MIDWEST POOLED FUND PROGRAM

Progress Report - First Quarter 2010 January 1st to April 2nd

Pooled Fund Consulting Summary

Midwest Roadside Safety Facility
January 2010 – April 2010

Figure 6. IL Tollway Standard B18-01

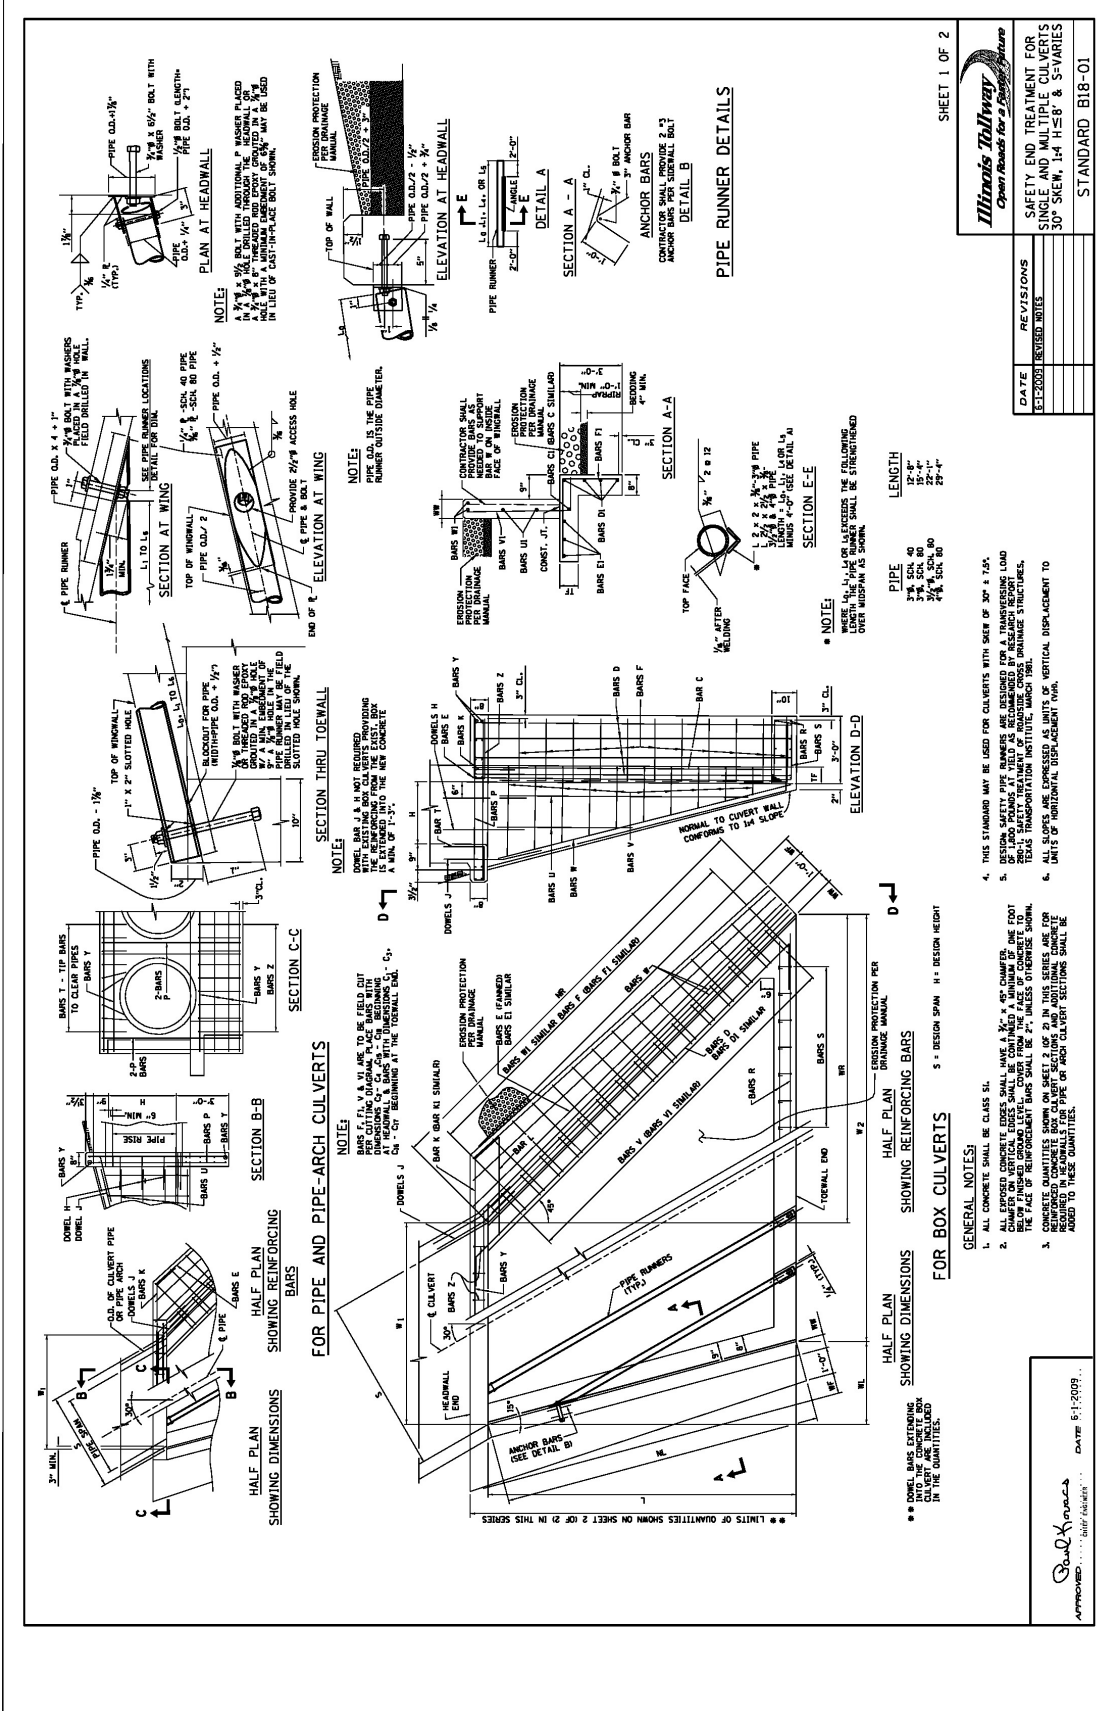
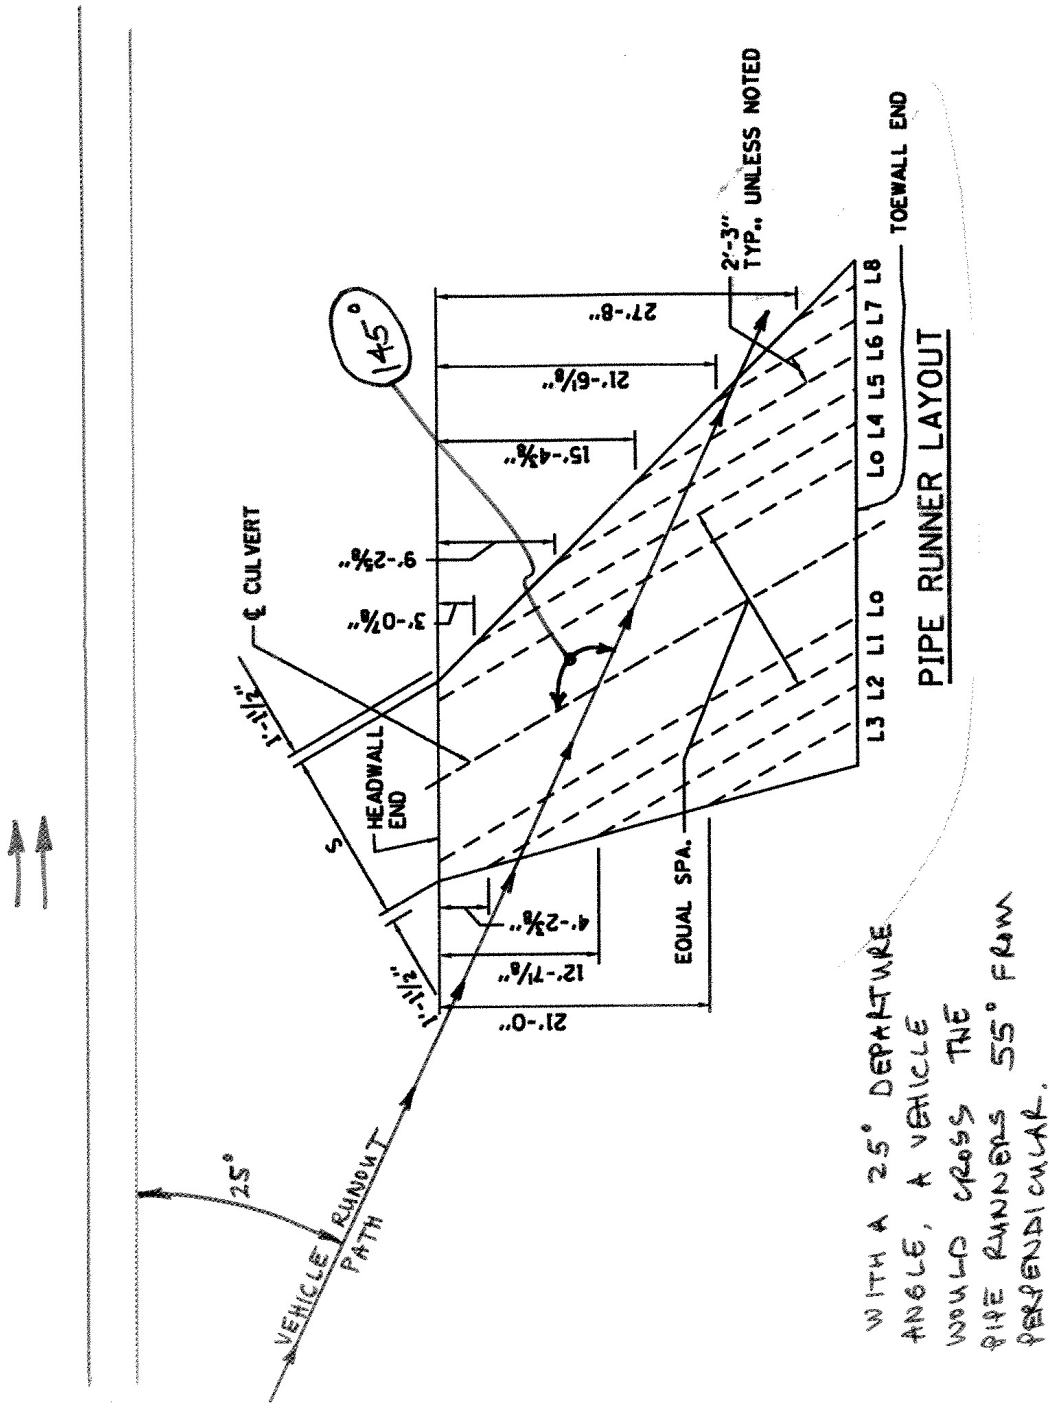
I am looking for guidance on the use of pipe runners at skewed culverts. The current IL Tollway standards show pipe runners perpendicular to the roadway when the pipe is perpendicular to the roadway. Based on a departure angle of 25 degrees, a vehicle leaving the road would hit the pipe runners 25 degrees from perpendicular. For our skewed pipes and headwalls, the pipe runners are shown parallel to the pipe. Therefore for a culvert that is on a 30 degree skew (right hand forward) with pipe runners parallel to the pipe, that same vehicle departing at 25 degrees would now hit the pipe runners 55 degrees from perpendicular. This seems like too much of an angle. I was under the impression that the pipe runners should ideally be perpendicular to the path of the departing vehicle. Is there guidance for usage of pipe runners on skewed pipes?

Figure 9. 54" TL-5 Concrete Barrier

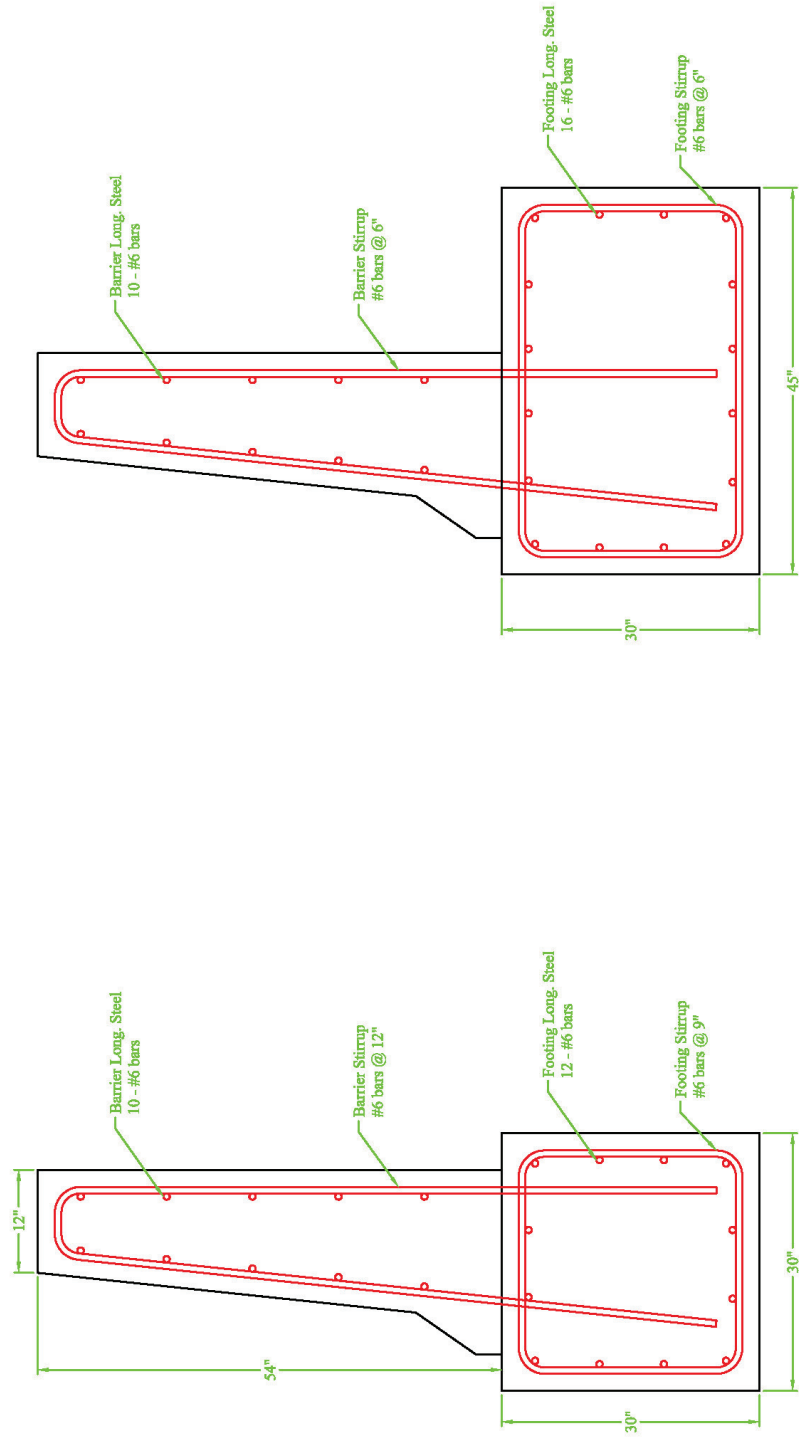
From the Roadside Design Manual we note that the F-Shape may be extended to a taller configuration by “following the slope of the upper face if the barrier is thick enough or adequately reinforced at the top, or the extension may be vertical” (6.4.1.7). However, this would not be adopted directly from the 51 inch barrier as provided in the 2004 work, but would appear to require some modification to the barrier and footing design.

- Adaptation of the footing for either of the 42 inch tall barriers to meet Illinois requirements (weaker soils, freeze thaw considerations).
- Modification of the 51 inch F-shape to a 54 inch height and with modifications to the footing design to accommodate this, plus the Illinois footing conditions.

See the attached PDF file for a simplified drawing for a 54" tall, F-shape, TL-5 barrier. A few notes:

1. The only difference between the interior and ends sections for the barrier is the reduction of stirrup spacing from 9" to 6".
2. All longitudinal steel should be evenly spaced
3. 10 of 12 longitudinal steel bars in the interior footing can continue through the end section footing as well. The remaining two bars should be extended at least 2 feet into the end footing.
4. The end section shows the barrier positioned on the front of the footing, but it could be placed on the backside of the footing as well.
5. Other footing dimensions can be created to provide adequate strength, however the steel reinforcement may need to be reconfigured.

Figure 10. 54" TL-5 Concrete Barrier

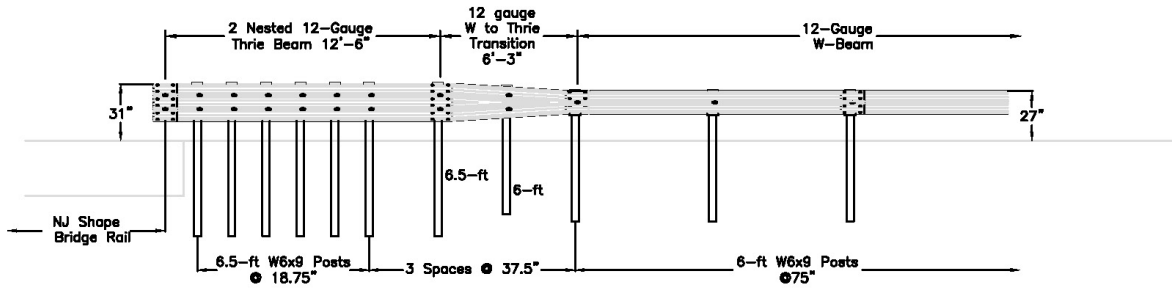
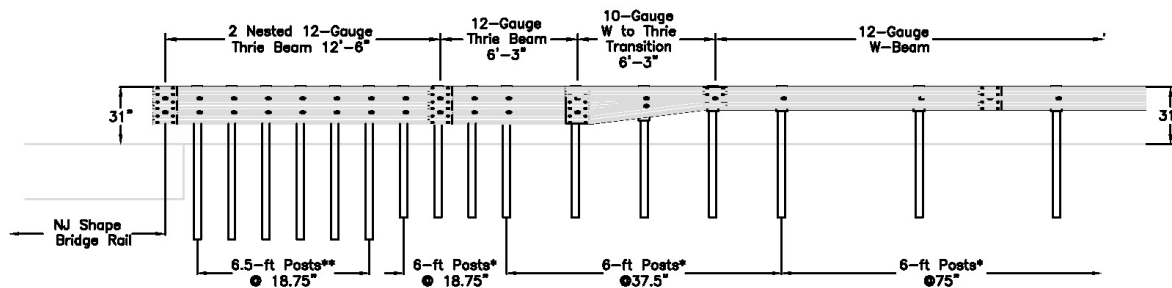
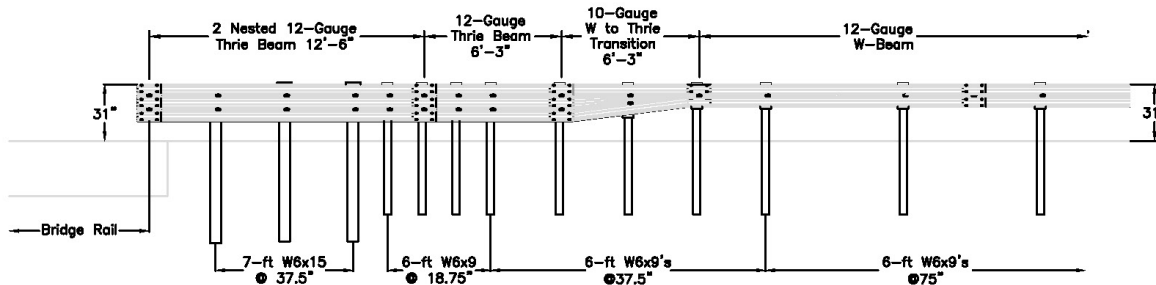
1. Do we substitute only the last 12’-6” of the Alaska Design into the last 12’-6” of the MwRSF tested option?
2. For the MwRSF tested transition, the next section upstream of the double nested 12’-6” segment is a 6’-3” single thrie beam section. The post spacing drops to a quarter post spacing (18 ¾”) as it approaches the double nested 12’-3” section, so do we need to add one additional post into the Alaska design between posts A6 and A7 so there is a consistency in the progressive stiffness of the system?

3. In the car crash test, I noted significant snagging of the vehicle as it impacted in the area of the asymmetric w-beam to thrie beam section, although the test was a pass. Would it be prudent to add one additional half post spacing between posts M11 and M12? This would essentially be option “L” I believe. Although the Pooled Fund voted to test option “K” since it would require one less post, I remember you guys were much more confident of option “L” passing.

I have previously drawn up the attachment of the newer MGS approach transition to an Iowa bridge rail transition that is very near the transition you sent to MwRSF with questions. Please see the attached PDF for these drawings.

The top design is of the Iowa transition, very similar to the one you submitted
The bottom design is the tested MGS approach transition – Design K.
The middle design is the Iowa transition with the approach (upstream) transition considerations.

Hopefully the middle design answers your questions about how to attach the approach (upstream) transition to your existing transition. If you need anything else, please let me know.

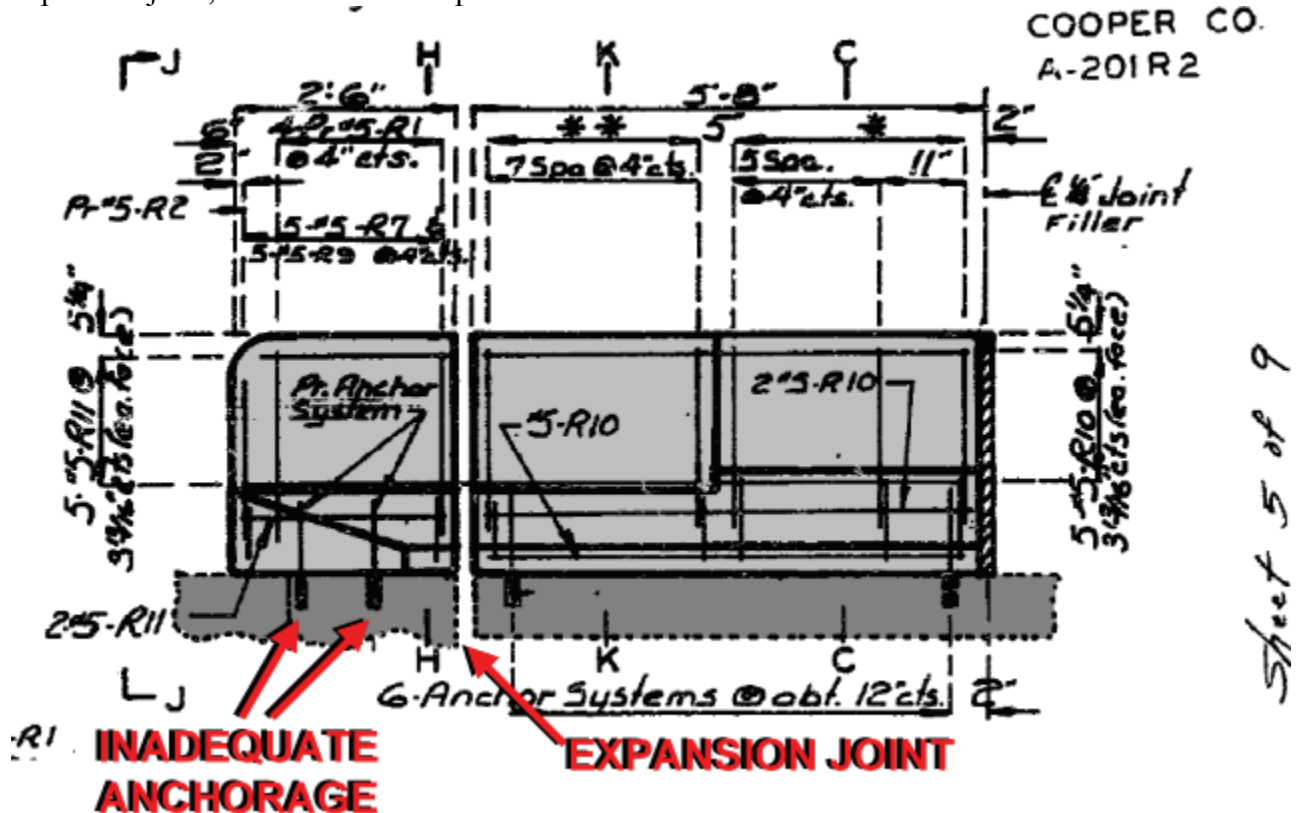
We have an old bridge on I-70 which, at one point in its life, was rehabed and new safety barrier curbs added. In order to attach the bridge anchor section of guardrail without spanning the expansion joint, a stand-alone end post was cast and the rail attached.

We believe the post was insufficiently anchored because subsequent hits on the rail have caused it to move out significantly. Obviously, we're concerned about future pocketing and know we have to fix it. I don't want to repair this setup because I don't believe it functions as well as it could, and, as these photos show, there isn't a lot of substrate to attach to.
